SERVICE BULLETIN NO. OSB817-52/1

G 109B

23-50 Audio Integrating

On customer request the optional installation of Mute Switch P/N 115E-9902E into the centre instrument panel is approved. The installation is approved only for the use in combination with the BECKER AR3201 radio.

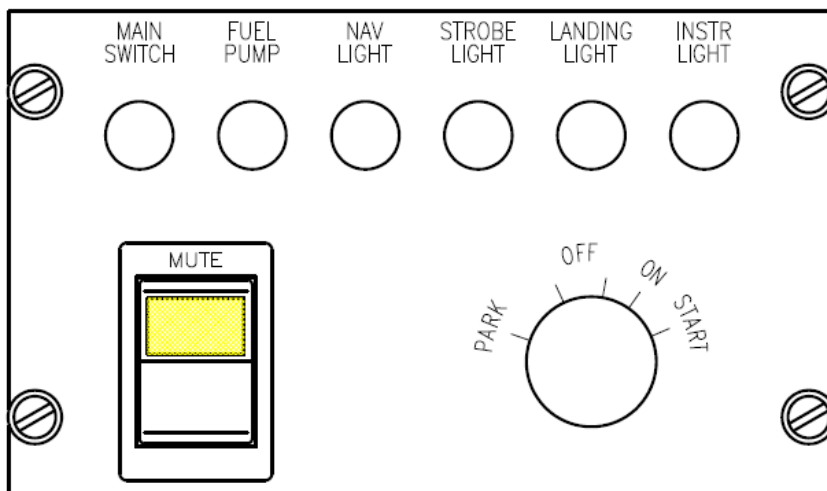
- 1.8.5. Install all toggle switches together with plastic angle P/N 109B-7000.32 (to achieve the necessary insulation between toggle switch connection and transponder unit) and the ignition switch into the new plate P/N 109B-7045E in the correct arrangement i.a.w. figure below. In case, the Landing Light switch has 6 tongues, remove the bottom 2 tongues. Rework the hole for the fuel pump of plastic angle 109B-7000.32 to fit with hole in plate 109B-7045E.

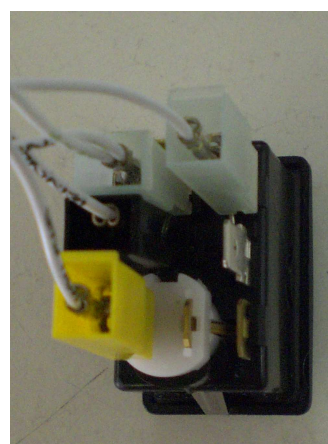
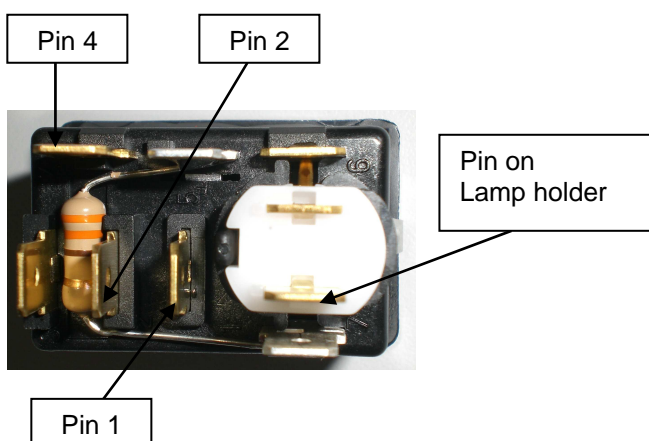
- 1.8.6. Install mute switch P/N 115E-9902E with yellow lens cover fitted to the plate. Replace filament by tail nav filament
- 1.8.7. Remove RH instrument panel.
- 1.8.8. Disconnect transceiver BECKER AR 3201 (2RV-a). Therefore remove radio and transponder for access, if required.
- 1.8.9. Connect the coloured housing of the new preassembled wire harness for the MUTE SWITCH in accordance with wiring diagram 109B-LP-93500 to the new MUTE SWITCH.
- black housing to Pin1
 - white housing to Pin 2 and Pin 4
 - yellow housing to Pin on the lamp holder
- Correct arrangement i.a.w. figures below.
